Technical Review of EPA Renewable Fuel Standard Program (RFS2) Regulatory Impact Analysis for Non-GHG Pollutants

American Petroleum Institute

May 4, 2010

Sierra Research, Inc.
1801 J Street
Sacramento, California 95811
(916) 444-6666

**Figure 3-1
Acetaldehyde Emission Rates versus Ethanol Content**

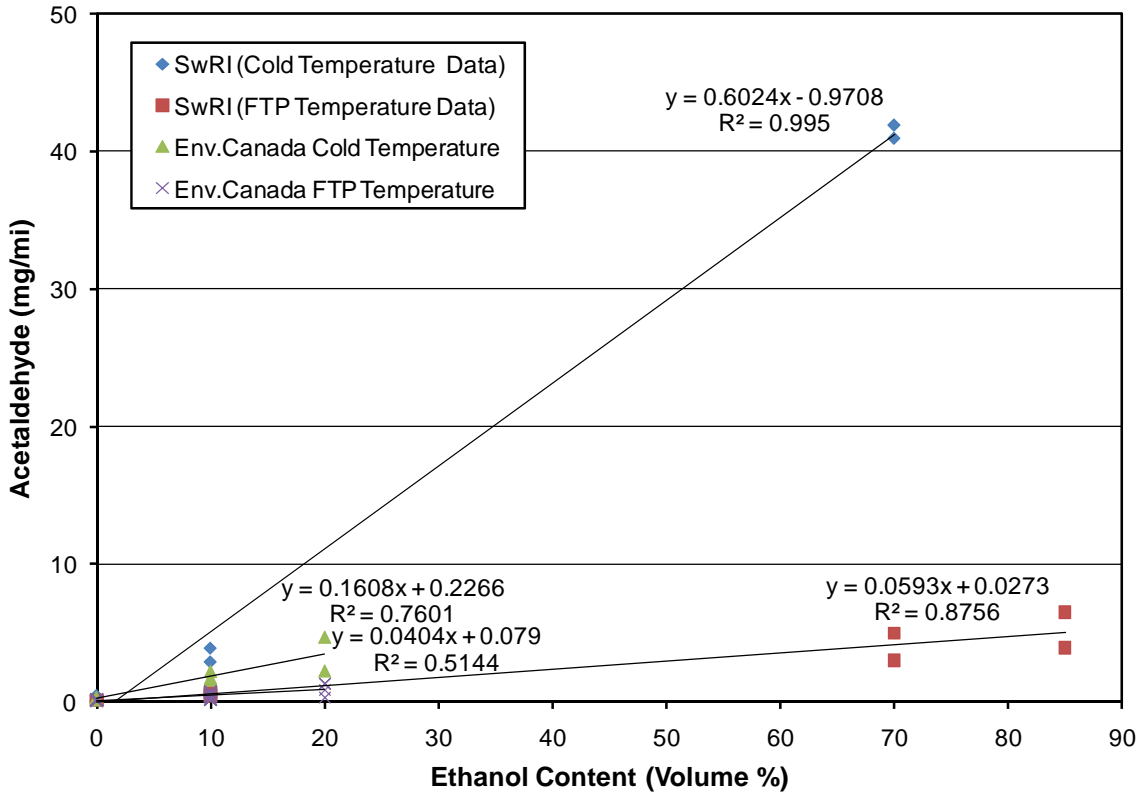
The discrepancy between the FRIA emission and air quality evaluations in terms of the assumed E85 methods is significant, however, and adds further concern about the relevance of the FRIA air quality evaluation results. In the control case of the FRIA air quality evaluation, 22 billion of the 34 billion gallons of renewable fuel are assumed to be in the form of E85, and the impacts are based on highly uncertain E85 effects for PM, NOx, and 1,3-butadiene. In the control case of the FRIA emission inventory evaluation, only 8 billion gallons of renewable fuels are assumed to occur in the form of E85 (and this review still finds that level of E85 consumption to be an optimistic upper bound), and the emissions impacts for all pollutants have been eliminated except for exhaust ethanol and acetaldehyde.
